# SCHEDULE OF CONDITION

**Internal Only Inspection  
relating to insurance claim  
and reinstatement work  
carried out for  
Mr & Mrs X by  
XXXX  
at**

**XXXX  
Chadderton,  
Oldham,  
Lancashire.  
OL9 XXX**

Lounge laminate flooring

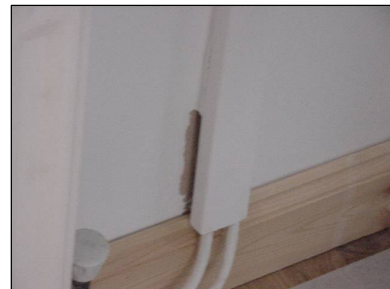
Very thin protective coat that has been applied over the timber flooring, note that the walls still need decorating as do the walls and the skirtings.
